Safety Defect and Noncompliance Report Guide for Vehicles
AMENDED PART 573 Defect and Noncompliance Report

On March 24, 2010, Motor Coach Industries, Inc. decided that a defect which relates to motor vehicle safety exists in the motor vehicles listed below, and is furnishing notification to the National Highway Traffic Safety Administration in accordance with 49 CFR Part 573 Defect and Noncompliance Reports.

MCI Service Bulletin 344

All E model and J model coaches equipped with a DOGA windshield wiper motor.

Road side wiper arms, before and after adjustment.

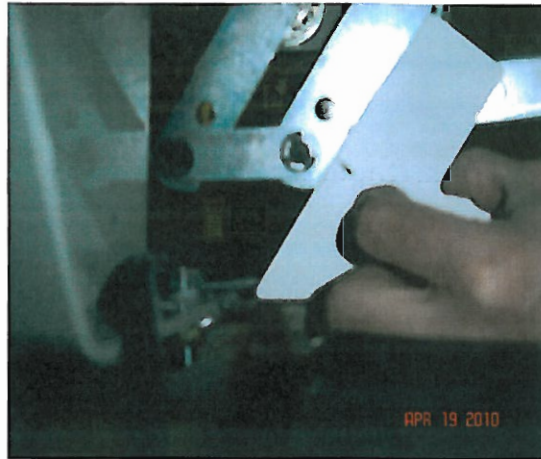
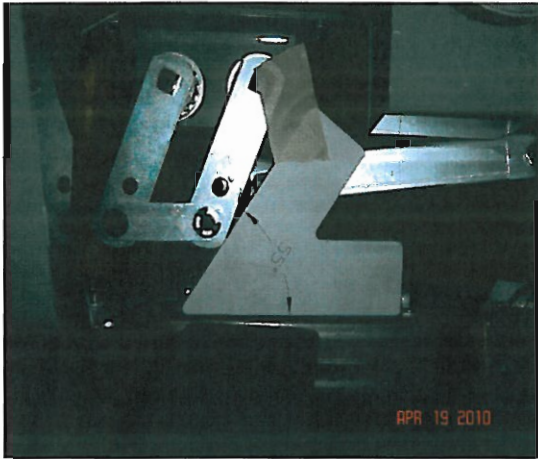
1. Adjustment of linkages to reduce torque on the motor.

Adjustment to the main wiper linkages is required so that the arm swing angle from the wiper arm pivot is 35 degrees on both sides vertical, which provides the optimal torque on the motor. Using an adjustment gage, the angle measured from the frame member is 55 degrees as shown.

Curb side wiper arms, before and after adjustment.

1. Set the linkages of the arms to the recommended angle of 35 degrees from vertical as shown in the following photographs.
2. Install a bypass harness on the controller that prevents the controller from switching the motor to high speed. A schematic of this bypass harness is shown below.
3. Install a new DOGA model 259 motor in place of the model 258 motor. The 259 motor has a higher load capacity than the current 258 motor, which is intended to provide an additional safety margin to the wiper system.

Schematic of by-pass harness

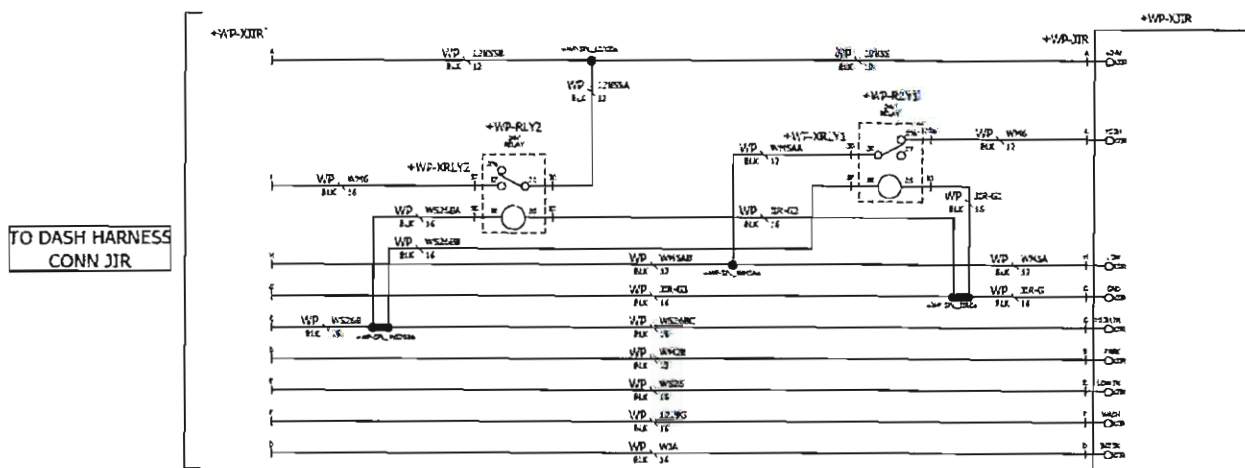
2. Add a by-pass harness to by-pass high speed output of the wiper controller. Reduces the amount of time the wiper motor operates in high speed.

The by-pass harness interfaces between the wiper switch in the steering column, the wiper controller and the wiper motor. The harness is installed by disconnecting the plug to the wiper control module and installing it. This harness prevents the wiper controller from operating the wiper motor in high speed mode in the event of increased current draw. The high speed operation is powered through a relay controlled by the column switch. The harness also prevents the activation of both the high speed and low speed function of the motor at the same time.
